FAQ Number 13-0006 FAQ Revision 0

FAQ Title Modeling Junction Box Scenarios in a Fire PRA

Plant: Various Date: May 6 2013

**Figure 14:** Layout of physical analysis units used in the conceptual example

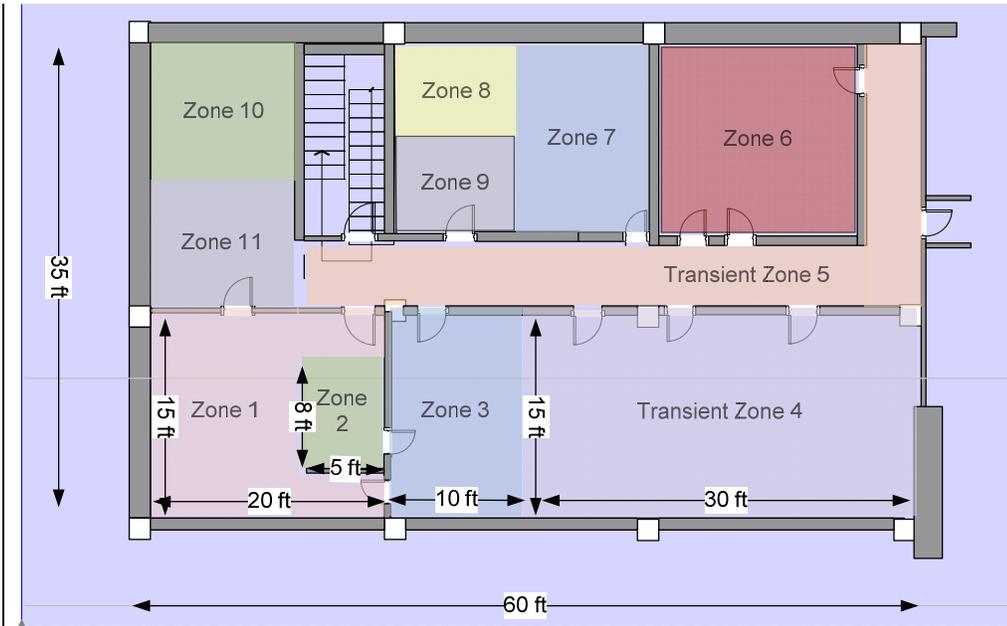
**Comment [J12]:** Figure no longer appropriate since not using transient zones.
